Planning Commission Staff Report

Meeting Date: June 22, 2020

Petition: **P.Z. 03-2020 Downtown Chesterfield (Wildhorse Village LP.)**: An ordinance amending City of Chesterfield Ordinance 3023 to amend the legal description and development criteria for an existing PC&R Planned Commercial and Residence District for a 99.6 acre tract of land located west and southwest of the intersection of U.S. Highway 40/I-64 and Chesterfield Parkway West (18T620185, 18T620206, 18T620053, 18T630272, 18T630195, 18T640248, 18T640260, 18T640271, 18T620174, 18T640183, 18S410240, 18S410206, 18S430259, 18S430282, 18T640336, 17T320158, 18T640237, 18T640259, 18T620064, 17T320169).

Figure 5: Connectivity Exhibit

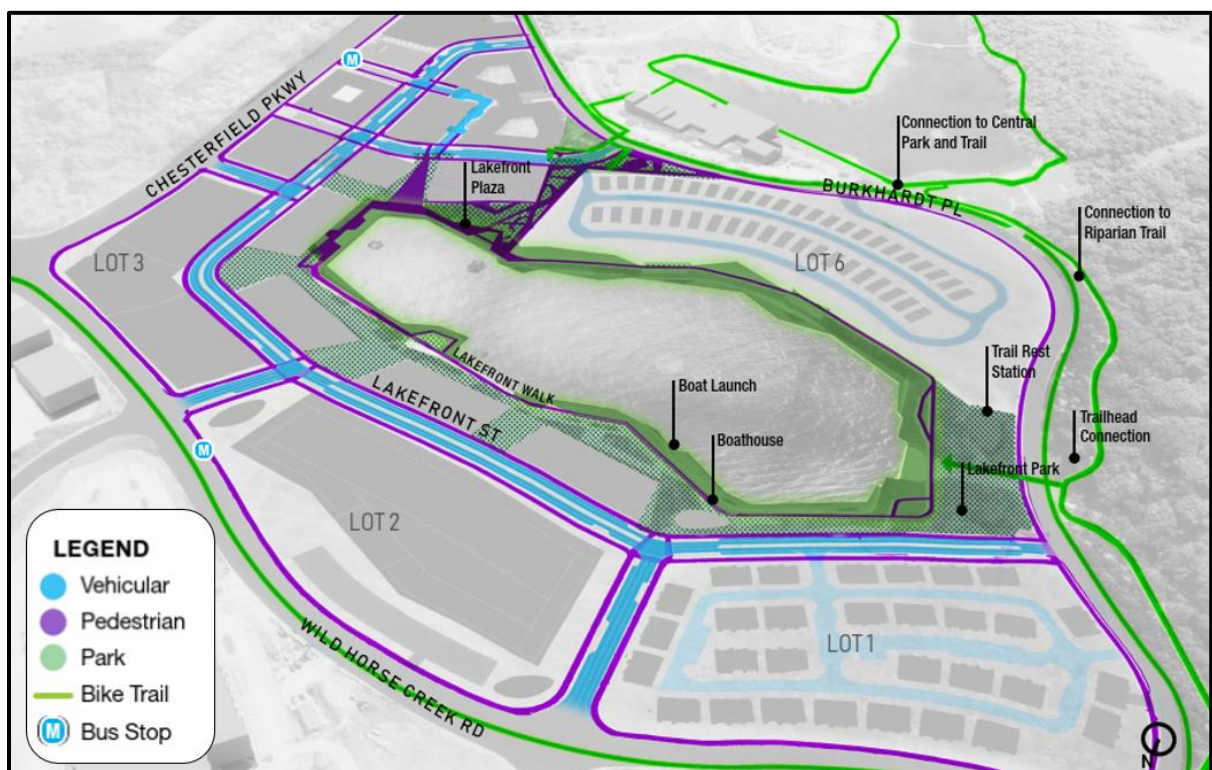
- **Issue:** It was stated that there is a desire to have a less auto-centric request for this zoning petition. It was also stated that there should be an increased focus on creative parking design and pedestrian connectivity. Provide additional information on how all modes of transportation will interact with the site internally and externally.

Response: *Wildhorse Village provides a well-connected pedestrian sidewalk and trail system within the development. This system connects with “all public walks and trails around the perimeter of the site. In addition, vehicular parking, while provided along Lakefront Street, is provided within centralized and convenient parking structures” (See Connectivity Exhibit).*

Figure 6: Ground Floor Activity Exhibit

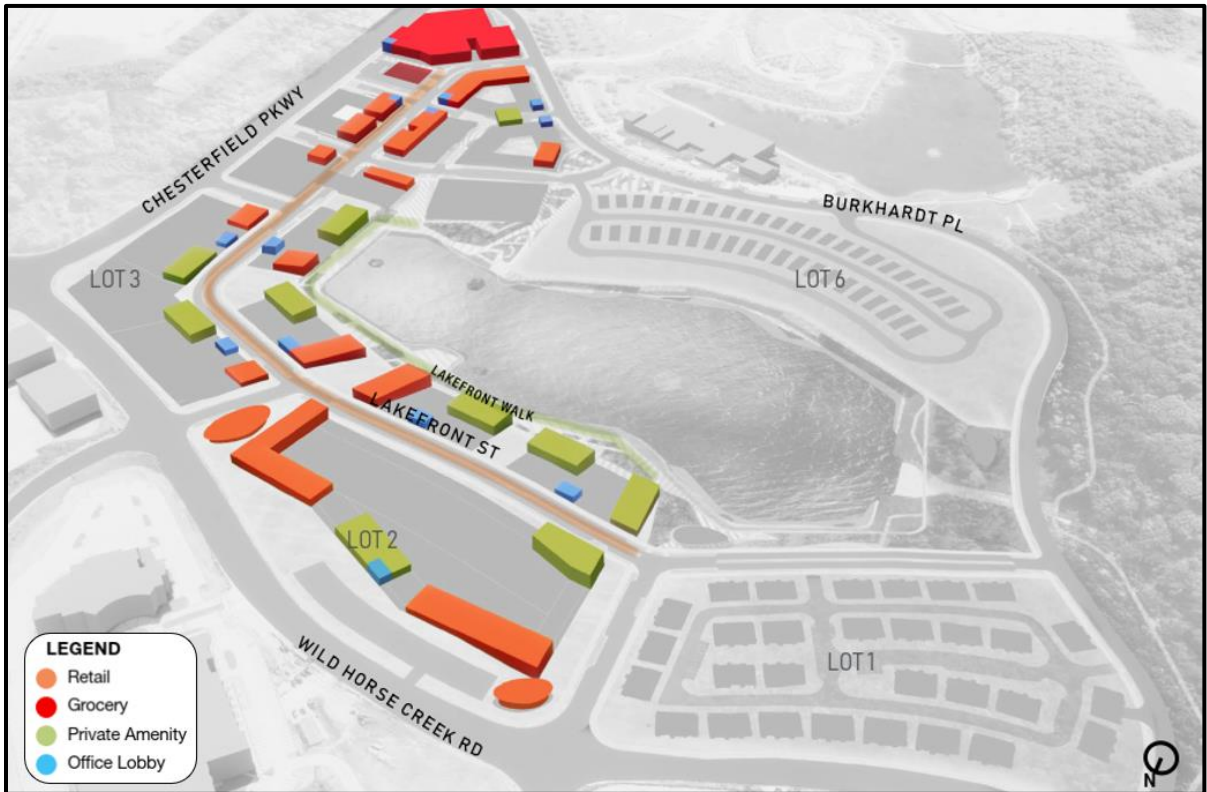
- **Issue:** It was acknowledged by the Planning Commission that they were comfortable with not having first-floor retail on all buildings, but there was a desire to see retail remain on the first floor of some buildings. A statement was made to establish a retail threshold that could be used to understand how much retail would be integrated into the buildings.

- **Issue:** There was concern from residents on removing the requirement for retail commercial on the first floor along the Lake Front Street. Provide information on how first-floor pedestrian activities and architectural design will remain along the Lake Front Street with or without retail.

Response: *The intent is to provide retail within both Category A and B which front Wild Horse Creek Road, Chesterfield Parkway, Lakefront Street, and along Lakefront Walk. (See Ground Floor Activity Exhibit)*

Response: (See Ground Floor Activity Exhibit – Figure 6)

Figure 8: Parking and Parking Garage Exhibit

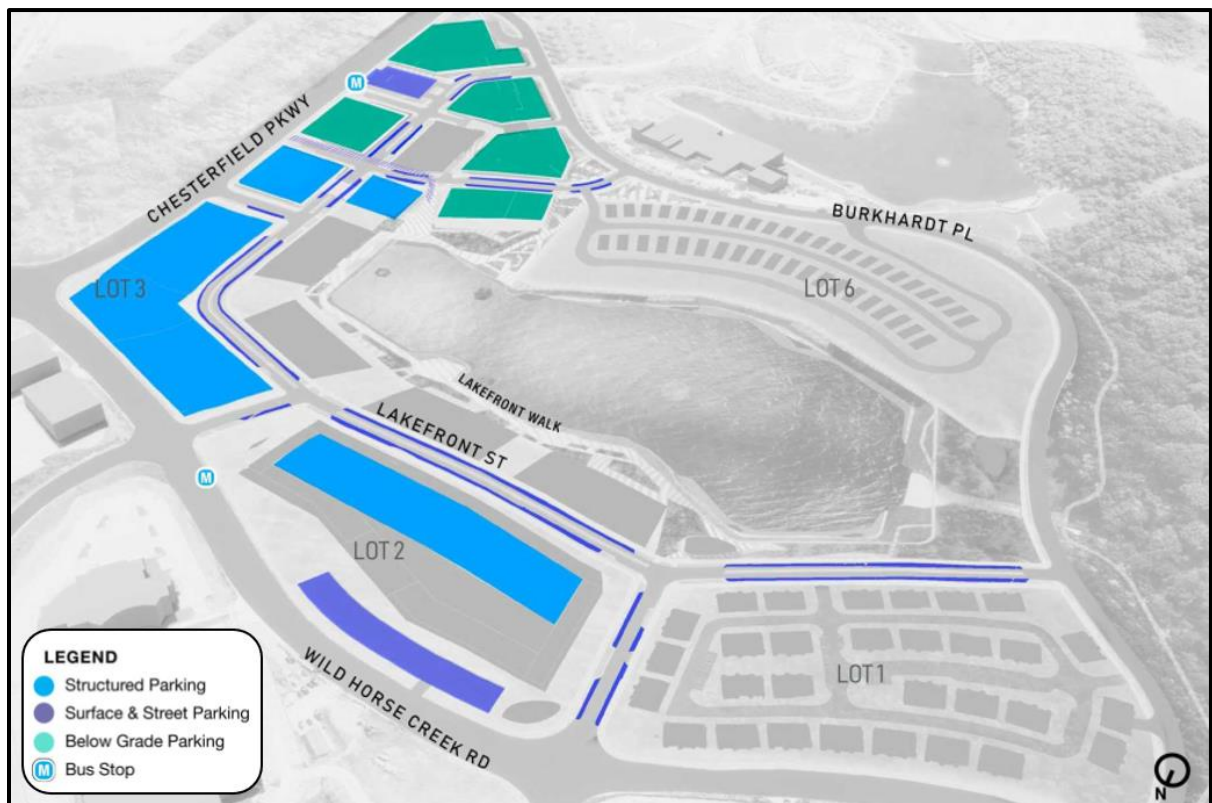
- **Issue:** A statement was made by residents to keep the language in the ordinance in regards to the ground floor retail requirement on parking structures along street frontages. There would be support to remove this requirement on roads if the ordinance contains language that surface parking lots in front of buildings are not permitted and that parking structures were placed behind buildings or that they are designed in such a way that they blend in with the architecture of the area. Provide a response in regards to the utilization of garages and their appearance and function.

Response: *We are proposing to revise the parking structure building function in both Categories A and B to read “Permitted – Ground floor retail commercial, office commercial, or an architectural design that blends into the surrounding area required along street frontage”. (See Parking and Parking Garage Appearance Exhibit)*

Figure 9: Public Amenities Exhibit

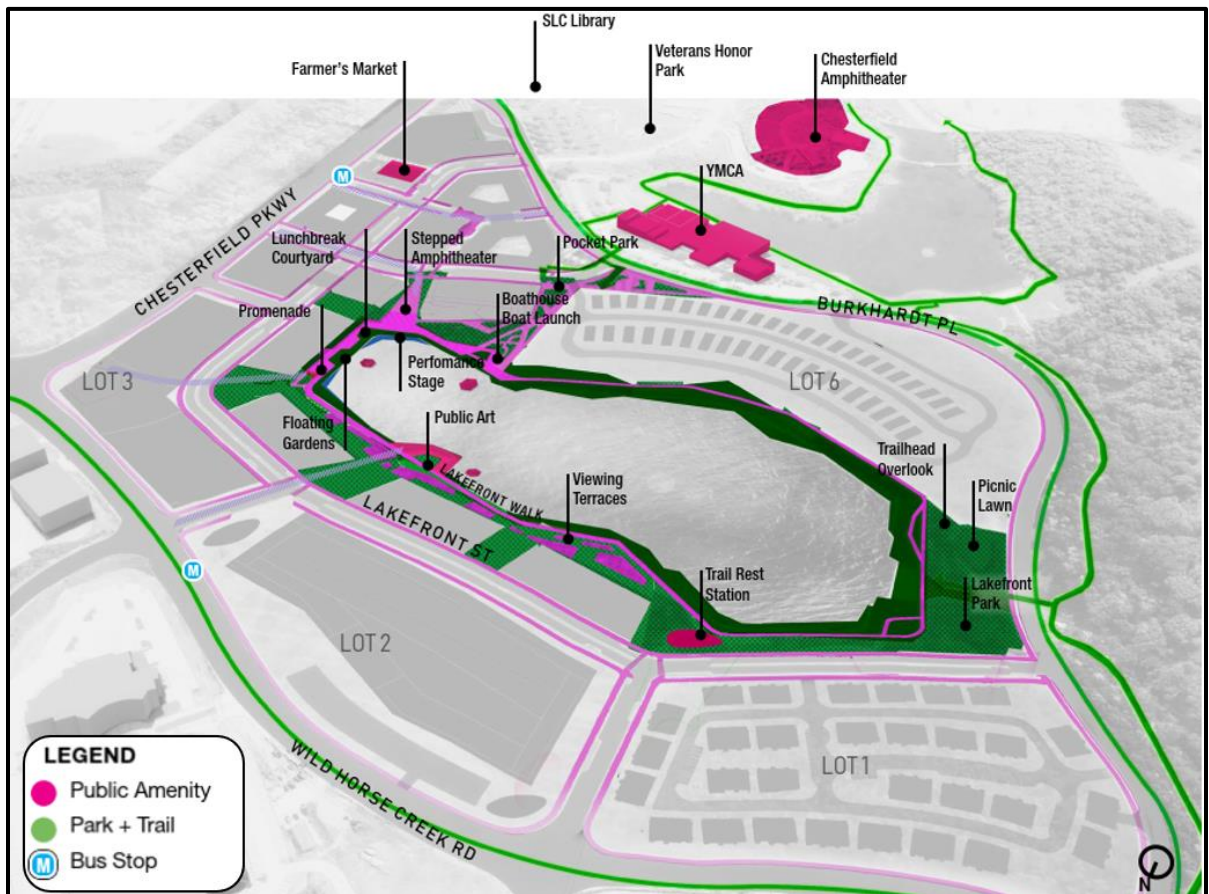
- **Issue:** Amenities are mentioned in the developer's narrative (ie, trails, a small amphitheater or other community gathering spot, boardwalks, trails around the lake, and a boathouse) in which there was a desire by residents to see them written into the ordinance. Provide a statement in regards to this request by the residents.

Response: *Cultural Features: Performance Terrace, Viewing Terraces, Floating Stages & Gardens, and Public Art. Recreational Features: Boathouse, Cycling Trail Rest Station, Trail Overlook, Picnic Lawns, and Pocket Parks. (See Public Amenities Exhibit)*

Figure 9: Lakefront Street Connectivity Exhibit

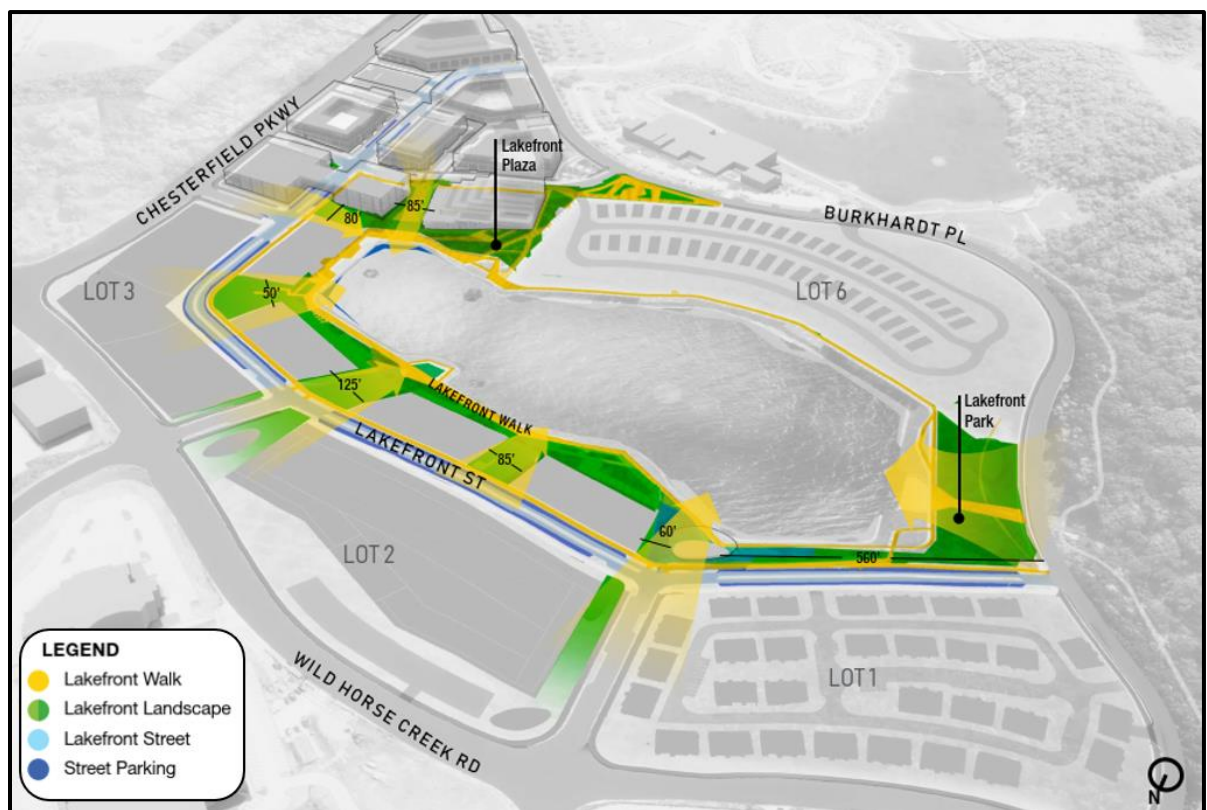
- **Issue:** There was a concern from residents about having buildings on both sides of the Lake Front Street. A desire was stated to minimize the amount of building on the lake side of a Lake Front Street. Provide a further explanation on the interaction of development between the Lake Front Street and the lake.

Response: *The office/mixed use areas will incorporate buildings on both sides of Urban Main Street or “Lakefront Street” with engagement to the lake front trail that encourages pedestrian interaction with the water and amenities being constructed as part of the public realm (See Lakefront Street Connectivity to Lake Exhibit)*
